Project	IEEE 802.16 Broadband Wireless Access Working Group < http://ieee802.org/16 >	
Title	Enhancement of DL Map transmission with STC in the first mandatory PUSC zone	
Date Submitted	2005-01-10	
Source(s)	Jason Hou, Sean Cai, Mary Chion, Jing Wang ZTE San Diego 10105 Pacific Heights Boulevard Suite 250, San Diego, CA92121	jhou@ztesandiego.com scai@ztesandiego.com mchion@ztesandiego.com jwang@ztesandiego.com Tel: 858-554-0387
Re:	Response to Sponsor Ballot on IEEE802.16e/D5a document	
Abstract	STC modulation for first-zone PUSC with DL-MAP and broadcast messages.	
Purpose	Adopting of proposed method into P802.16e D6	
Notice	This document has been prepared to assist IEEE 802.16. It is offered as a basis for discussion and is not binding on the contributing individual(s) or organization(s). The material in this document is subject to change in form and content after further study. The contributor(s) reserve(s) the right to add, amend or withdraw material contained herein.

Enhancement of DL Map transmission with STC in the first mandatory PUSC zone

Figure xxx- Cluster structure for First-zone STC.

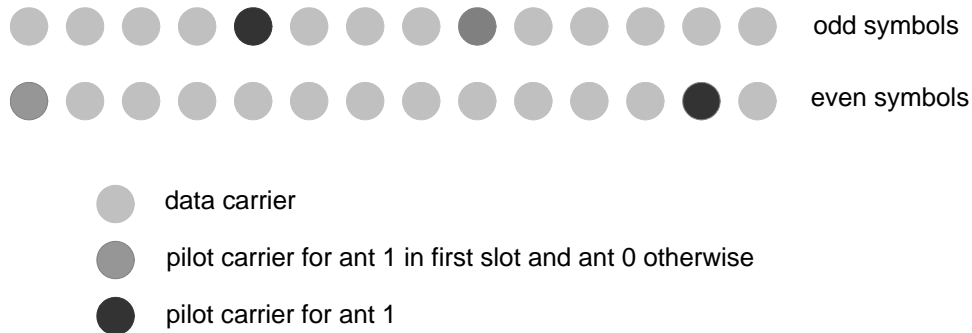
The clusters comprising the subchannels used by the First-zone STC modulation shall be allocated and subcarriers numbered as defined in 8.4.6.1.2.1. The cluster structure is depicted in Figure xxx. With an exception of FCH subchannels, encoding of the First-zone STC is depicted in Figure yyy. The FCH subchannels shall not be STC encoded. The First-zone STC mode is enabled via Coding Indication contained in the DL Frame Prefix (8.4.4.3). For preamble symbols and FCH subchannels transmission, antenna 1 transmits null data in the corresponding data tones. Demodulation of DL Frame Prefix that contained in FCH subchannels is thereby unaffected from the single-antenna TX configuration and is fully compatible with the mandatory PUSC modulation.

Figure yyy. Encoding of STC for use with First-zone PUSC.

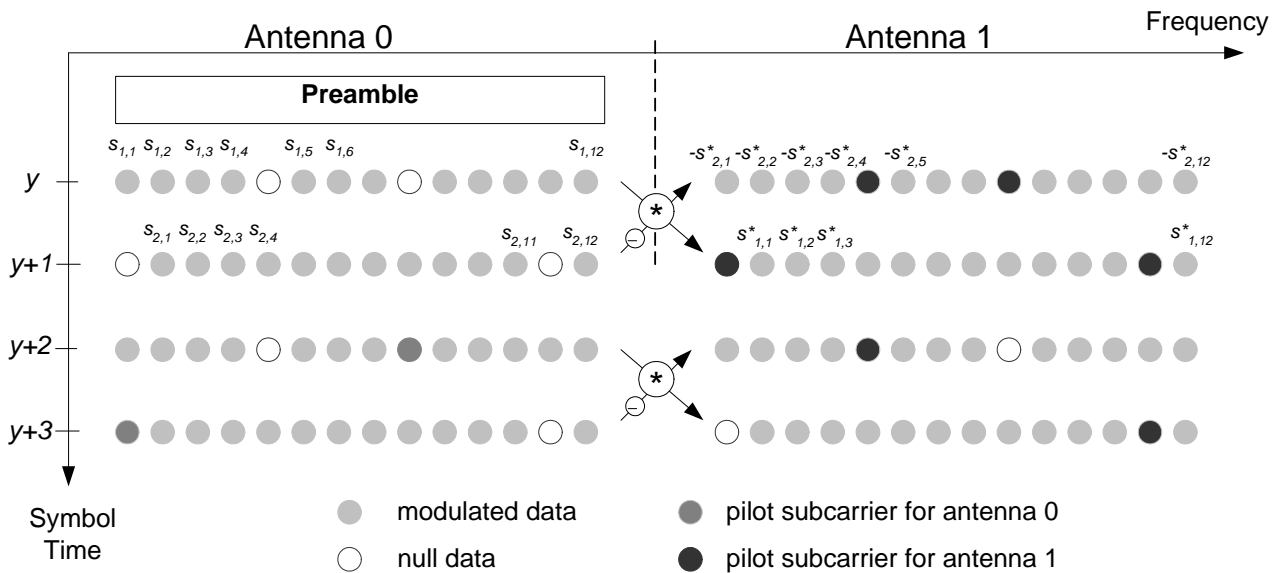
The pilot tones in the first slot (first two OFDMA symbols after the preamble symbol) shall be transmitted by antenna 1 for use in channel estimation. Thereafter the pilot tones are divided between antenna 0 and 1. Modulation of pilot tones are depicted in Figure yyy.
